FIELD CHANGE ORDER

NUMBER: DS-183Q1-F001

FCO DS-183Q1-F001

INTERCONNECTION OF MIRA MODULES (SYSTEM A is shown)

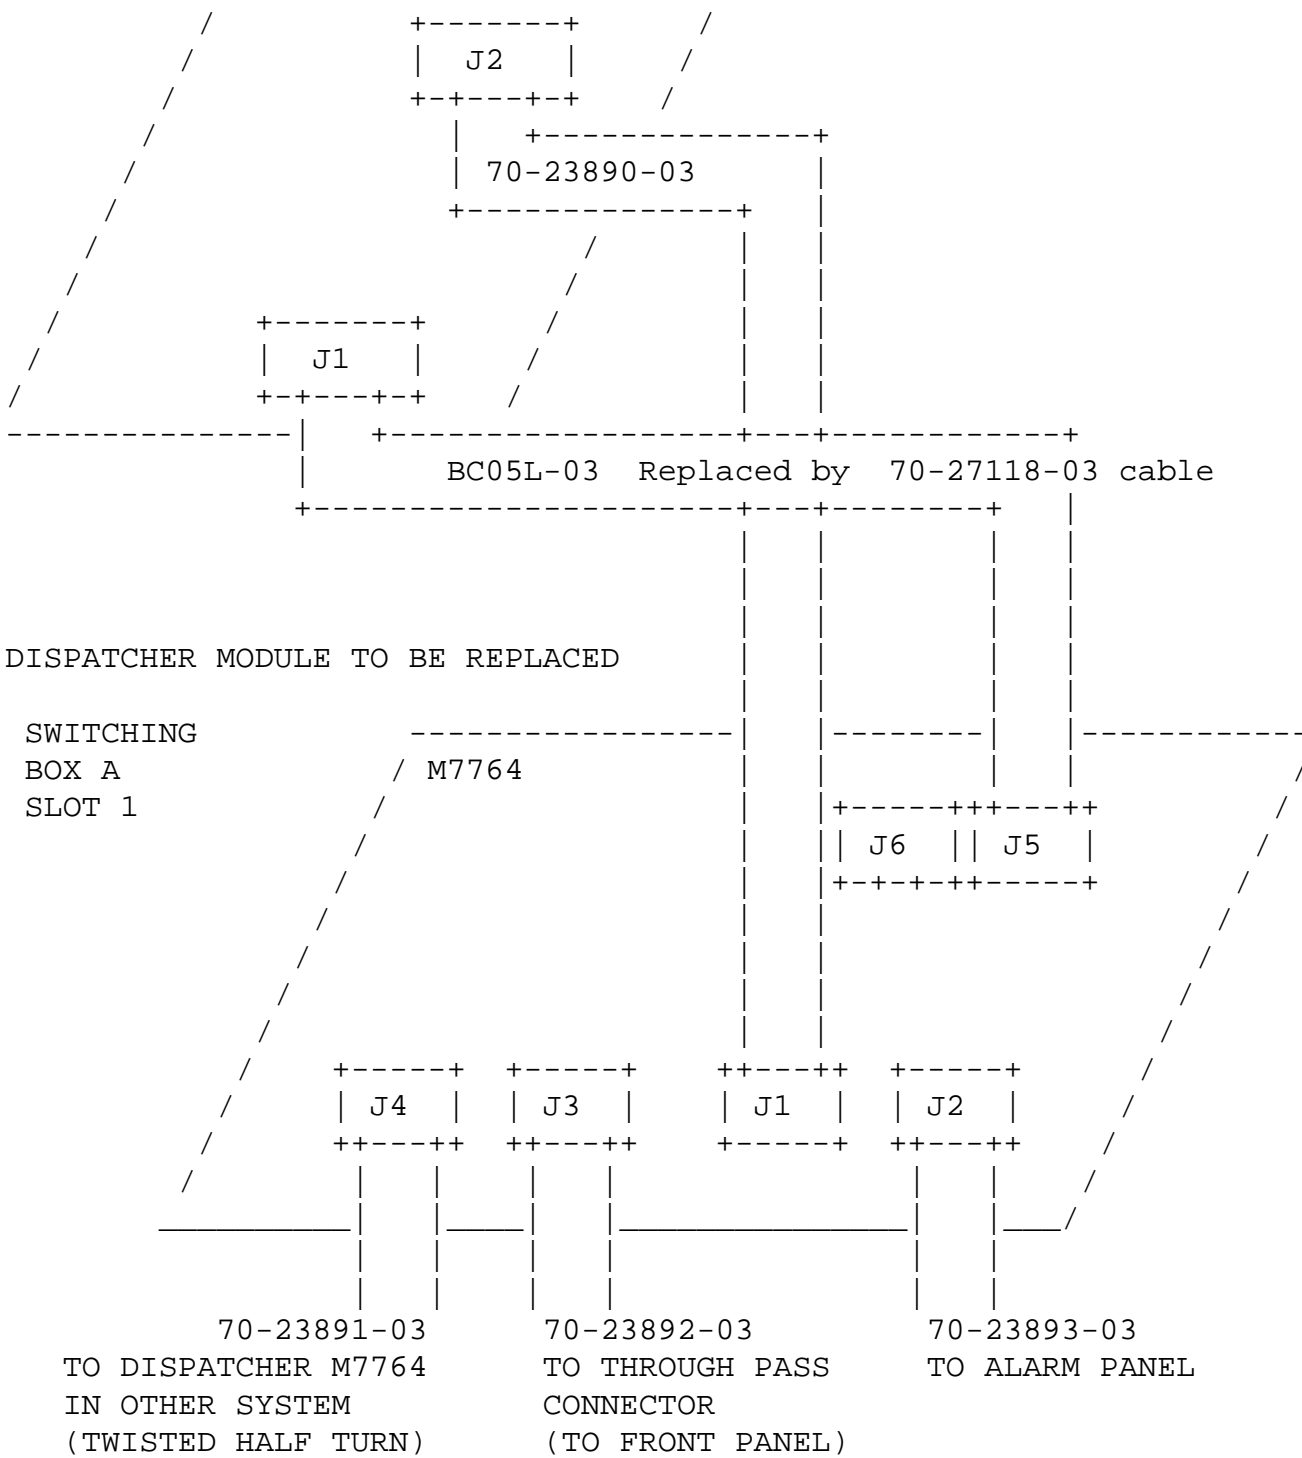
Intermittent data corruptions happen when testing switched KMV1A with XXDP Diagnostics in MIRA Systems. The data was corrupted by cross-talk between cables generated by the BC05L cable between the MIRA watch-dog module (M7763-00) and the dispatcher module (M7764-00).

necessary to adapt the impedances between these modules. Both M7764 and M7763 become Revision E with the new etch. A new cable 70-27118 has been designed to replace the BC05L cable.

WATCH DOG MODULE TO BE REPLACED

The interconnection of modules and cables to be replaced is shown on Page 4.

Replace all modules M7763 and M7764 at Revision D or below by new modules at Rev E and replace BC05L dispatcher cables at one time.

This FCO replaces all watch-dog, dispatchers modules and BC05L cables attached to these dispatchers. This replacement requires the complete MIRA to be powered down.
